Scanware Vision Systems Hardware Obsolescence Notification

March 31, 2021

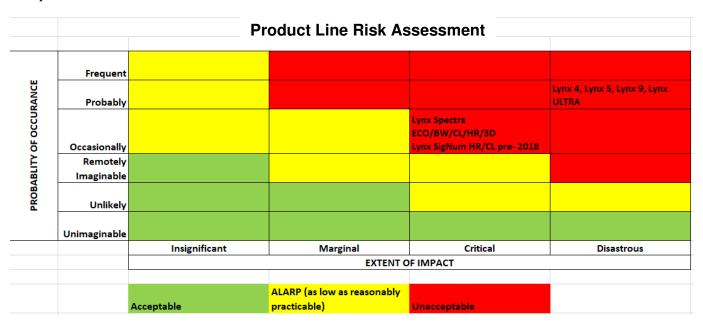
<u>Our records indicate the following Scanware equipment is at your facility along with the status of the impacted subcomponents.</u> Please take a moment to confirm the status of the equipment – not only for our records, but also to allow us to ensure that we can provide you with the best options for getting those units updated to an Active/Fully Supported status.

NOTE: **Line 4 (system 206.300.00.01.004) has a replacement unit (system 219.300.00.01.133) at your facility awaiting install. This system <u>has</u> the latest/supported CPU (model SC-1)**
